Form 3160-5 (April 2004) UNITED STATES DEPARTMENT OF THE INTERIOR BUREAU OF LAND MANAGEMENT

SUNDRY NOTIC	NMLC054667			
Do not use this form abandoned well. Use	6 If Indian, Allottee or Tribe Name			
SUBMIT IN TRIPLICA	7 If Unit or CA/Agreement, Name and/or No			
I Type of Well Oil Well □ □ Gas Wel	II Other		0 W 1121 AN	
2 Name of Operator DC Energy LLC	8. Well Name and No Crosby Deep#3			
3a. Address	9 API Well No 30-025-1185 // B 7 ()			
105 Oscar Lane Dallas Georgia 30132	10. Field and Pool, or Exploratory Area			
4 Location of Well (Footage, Sec., T., R., M., o.	11 Course Provide Course			
Sec 33 T25S R37E 1980' FSL 1980FEL	11 County or Parish, State			
			Lea	
	ATE BOX(ES) TO INDICA		E, REPORT, OR OTHER DATA	
TYPE OF SUBMISSION		TYPE OF ACTIO	N	
[7]	idize Deepe		n (Start/Resume) Water Shut-Off	
		re Treat Reclamati		
	Subsequent Report Casing Repair Change Plans New Construction Recomplete Plug and Abandon Temporarily			
Final Abandonment Notice Convert to Injection Plug Back Water Disposal

WELL BORE SCHEMATIC OF CROSBY DEEP#3 USTR J, SEC33 TASS, R37E 1980' FSLE FEL API 30-025-11870 DC ENERGY LLC AFTER PLUGGING.

Crosby Deep 3
30-025-11870
DC Energy LLC
March 21, 2012
Conditi

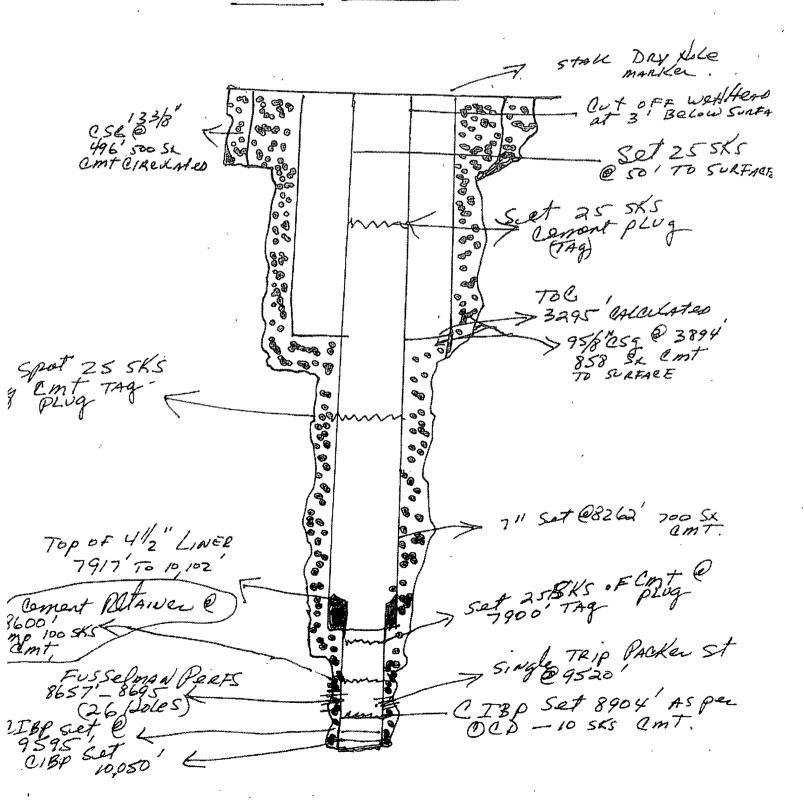
- 1. Operator has not submitted a copy of the CBL run in the well as required by the December 30, 2011 approved sundry. The CBL might modify some of the requirements in this procedure.

- 2. After installing BOP, operator shall clean out hole with a bit and scraper to the CIBP at 9595' and place a 25 sack Class H cement plug on CIBP. This will properly isolate the McKee formation and was required in the COA for the sundry approved on November 22, 2011.

- 3. Operator shall run a gauge ring to top of liner to verify that 7" CIBPs can be set.
- 4. For the Fusselman perforations, operator shall set a minimum of 25 sack Class H (not Class C) cement plug from 8750'-8580'. WOC and tag cement at 8580' or shallower. Due to past problems getting down in this well, the cement retainer is not approved.

- 5. Plug required across 7" shoe. A minimum of a 25 sack, Class H plug shall be set from 8320' to 8080'. WOC and tag at 8140' or shallower. This will provide a plug across the 7" shoe and cover the top of the Devonian.

- 6. Operator has the option of pumping sufficient cement in step 5 to obtain a cement top of 7800' or shallower. WOC and tag plug at plug at 7800' or shallower. This plug will cover the Fusselman perforations, the 7" shoe, the Devonian perforations and the 4 ½" liner top.

- 7. Operator can set a separate plug for the 4 ½' liner top by placing a minimum of 25 sacks of Class H cement from 7970'-7800'. WOC and tag at 7800' or shallower.

- 8. A 150' plug is required at the top of the Glorietta (top 5096'). Operator shall perforate at 5150'. Attempt to establish circulation, if circulation is established, pump a minimum of 25 sacks of Class C cement. Tag plug at 5000' or shallower. If circulation cannot be established, set plug from 5200'-5000' and tag at 5000' or shallower.

- 9. BLM inspector to be on location when operator performs free point on the 7" casing. If free point is above 3950' (near intermediate shoe) operator is to contact BLM prior to cutting casing.

- a. If the free point is above 3800', the intermediate shoe plug shall be set in the following manner. CIBP shall be eliminated. Operator shall perforate at 3950' and attempt to establish circulation. If circulation can be established, operator shall pump sufficient cement to achieve a plug length inside and outside of 140'. Plug shall be a minimum of 25 sacks of Class C cement. Plug shall be tagged at 3810' or shallower.

10. Cut casing at free point and place a 135' stub plug from 50' inside. Plug shall be tagged a minimum of 50' above the cut.

11. Top of Yates/Base of Salt plug required. Operator shall set a minimum 25 sack Class C plug from 2565'-2440'. Plug to be tagged at 2440' or shallower.

12. Top of Salt plug required. Plug to be a minimum of 25 sacks Class C and set from 1200' to 1090'. Plug to be tagged at 1090' or shallower.

13. Operator's step 4 – CIBP to be moved to a depth of 550'. Place sufficient cement on top of CIBP to bring cement to surface. This will provide additional protection for the surface water.

14. Operator will check all annuli when well head is cut off to verify cement to surface in all annuli.
